Increased Clock Speeds and Faster Initial Burst Access on Am29BDDI60G

Application Note

Increased Clock Speeds and Faster Initial Burst Access

Modification to Burst Initial Access Delay Control and CFI Device Geometry Definition—Revision 4a versus Revisions 4 and Earlier

Figure 1. Burst Initial Access Delay Control

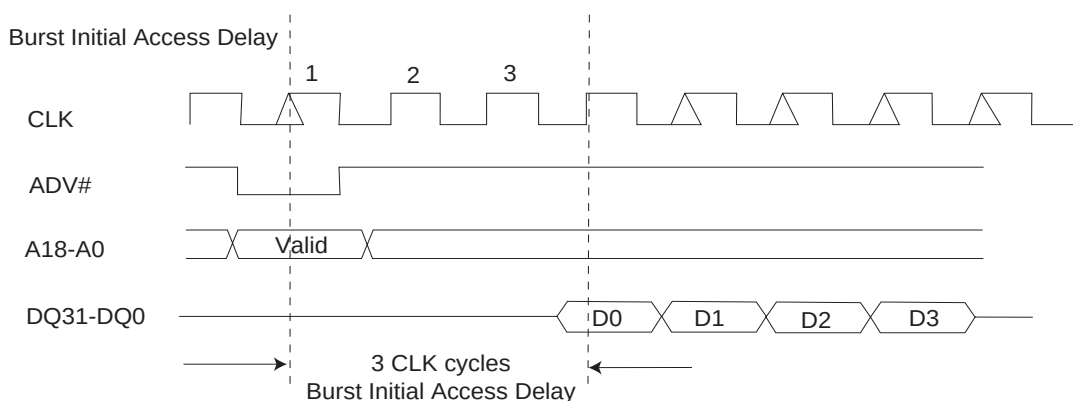
Design modifications have decreased the Burst Initial Access Delay by one clock cycle for all control register configuration values and for frequencies up to 66 MHz. Configuration Registers CR13 through CR10 determine the Burst Initial Access Delay. The Burst Initial Access Delay is defined as the number of CLK cycles that must elapse from the first valid clock edge after ADV# assertion (or the rising edge of ADV#) until the first valid CLK edge when the data is valid. Figure 1 and Table 1 are valid for the majority of applications, and have the following operating conditions:

For example, Revision 4 control register setting CR[13-10] = 0010 results in a Burst Initial Access Delay of five clock cycles; while Revision 4a the same control register setting results in a Burst Initial Access Delay with four clock cycles.
